Request For Information

Project Name: Replace Roofs (Program Phase 1 - 4)

Title: Roof Replacement - Phase 1 Facility B

RFI#: 014

22-090 CIM REPLACE ROOF - PH 1
RFI 14 - EXPANSION JOINT SYSTEM

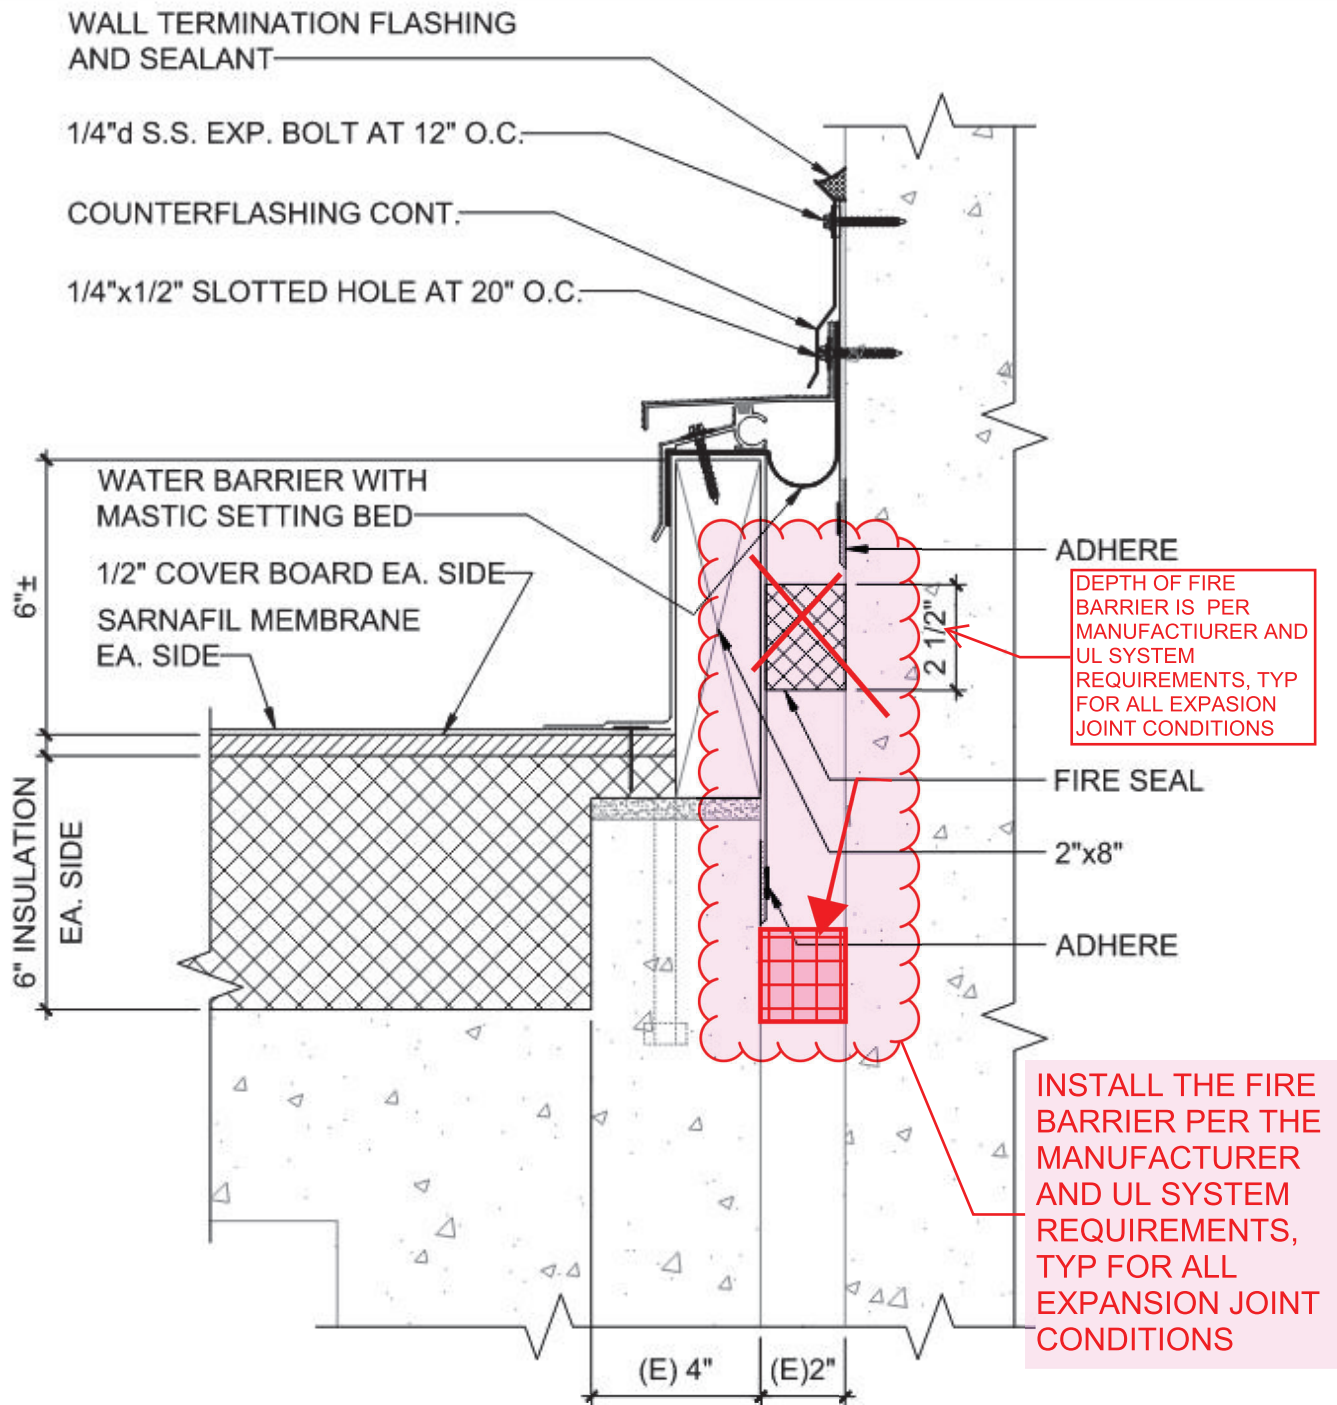
CCM Field Request to use attached Balco Expansion Joint System. Attached Balco shop drawings shows Metablock installed concrete substrate to concrete substrate. Detail A3.1-1 does not show Metablock. Details A3.1 -2,3,4 show meta block placed between FTD lumber and concrete substrate. RFI 013 Response clarified UL Listings, Balco systems complies with UL Listings' Field recommends using attached Balco Fire Rated System. Please Advise.

Proposed Balco Expansion Joint system is acceptable. Note that consultant details show location of fire barrier between nailer and concrete or between nailers. Per the Balco and UL system, fire barrier is to be installed between concrete elements, typical for all expansion joint conditions. Consultatant detail also specifies the depth of the fire barrier but the depth shall be per the manufacturer and UL system, typical for all expansion joint conditions. See attached SK1 for clarification. Consultant has been asked to provide corrected details as part of RFI 13 and this will be documented in a future CB.
